DCHC MPO

CTP -- Amendment #1

Amendment #1

Comprehensive Transportation Plan (CTP) DCHC MPO -- Amendment #1

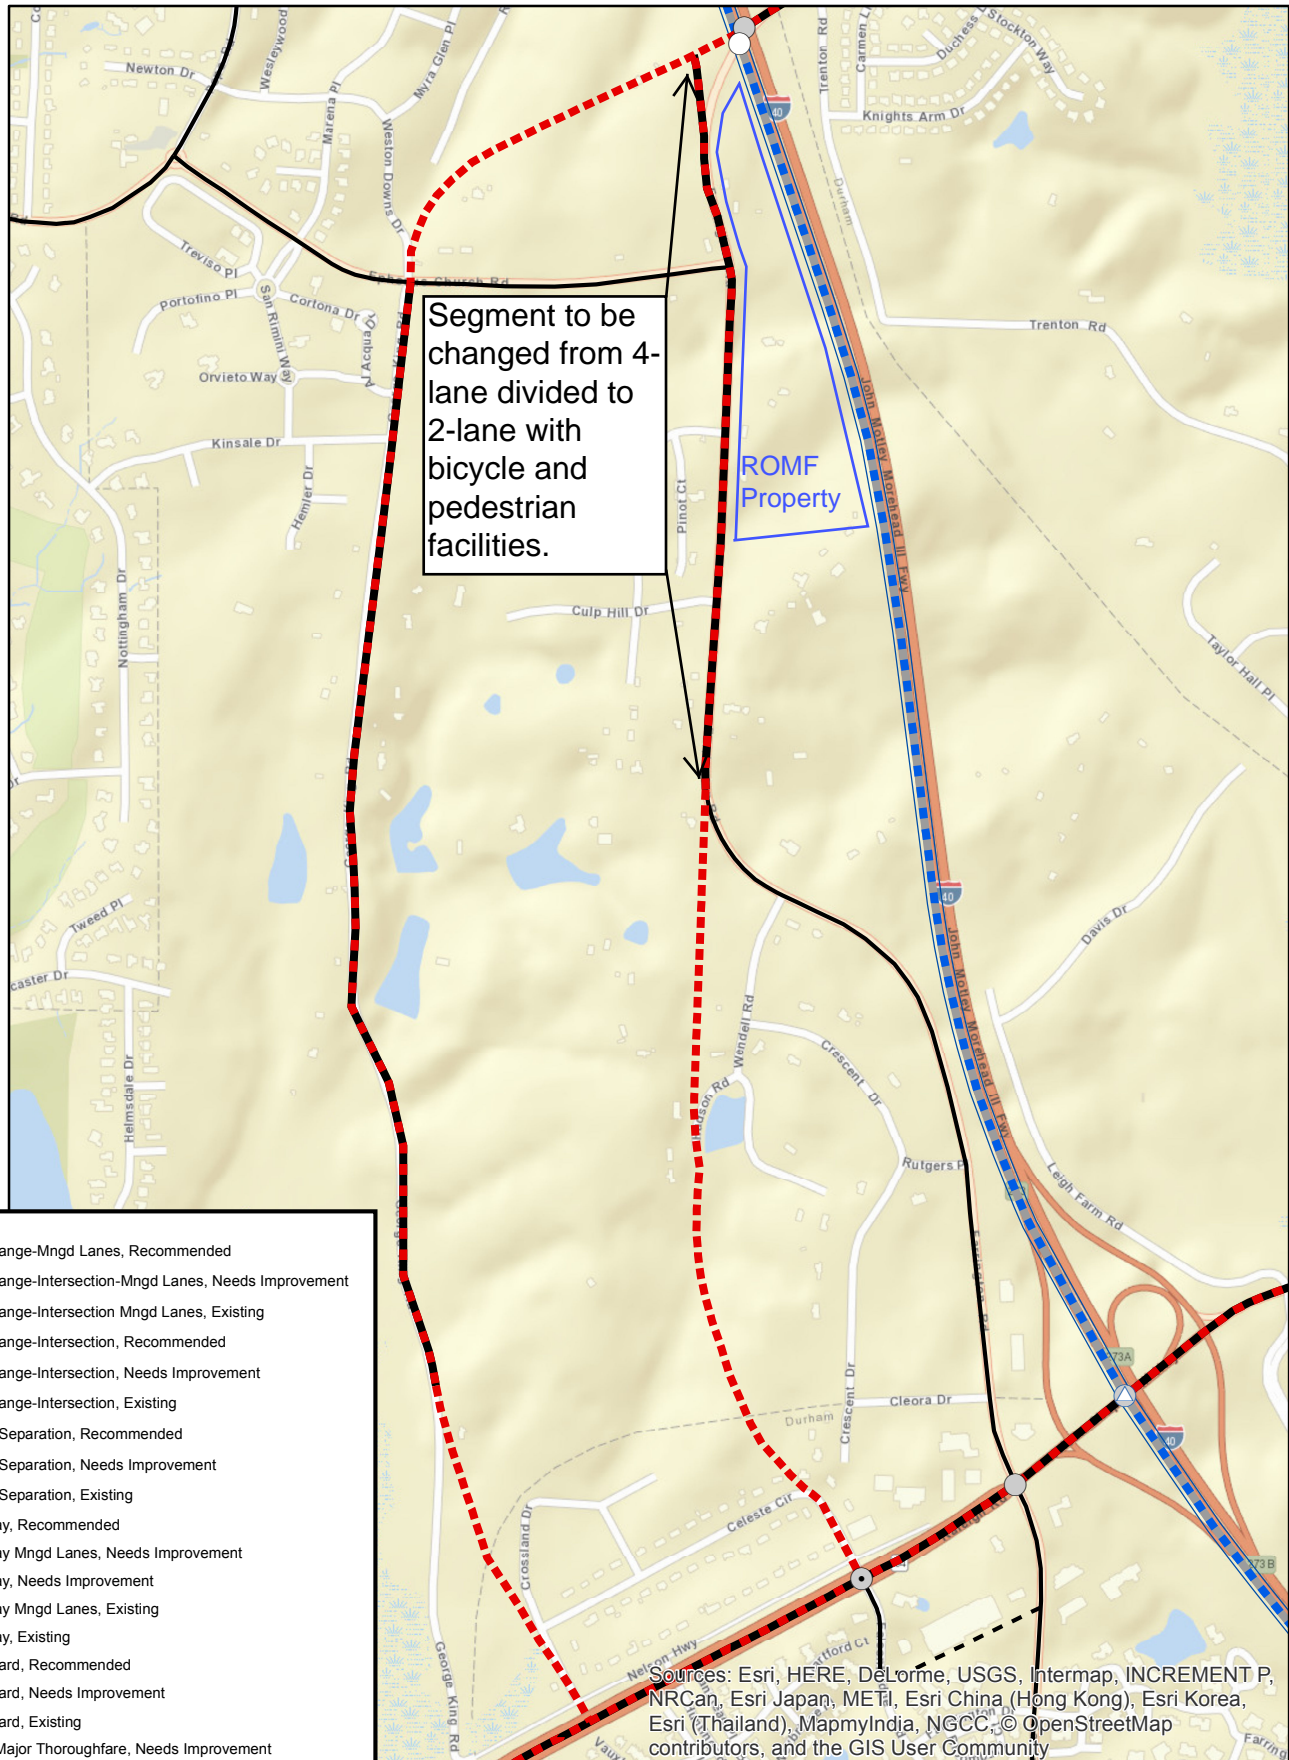
The Durham-Chapel Hill-Carrboro Metropolitan Planning Organization (DCHC MPO) proposes that the DCHC MPO and NCDOT amend the Comprehensive Transportation Plan (CTP) to change the proposed future configuration of the segment of Farrington Road between Southwest Durham Drive and the Falconbridge Road Extension. The CTP currently lists this roadway segment as a future four-lane divided cross-section. The MPO believes that a two-lane cross-section that includes bicycle and pedestrian facilities is more appropriate for forecasted traffic volume in that corridor and the future, adjacent land use. The segment of Southwest Durham Drive that is north of the Southwest Durham Drive/Farrington Road convergence (i.e., close to where the converged roadway crosses I-40) is defined as a future four-lane divided facility. This converged roadway will be capable of handling the combined vehicles to/from the 2 two-lane roadways to the south, i.e., Farrington Road and Southwest Durham Drive.

The table below shows the current and proposed amendment #1 attributes for this segment of Farrington Road in the CTP. The proposed changes are shown in **bold blue** font – the cross section will be 2E (2-lane with bicycle and pedestrian facilities) and the classification will be minor arterial.
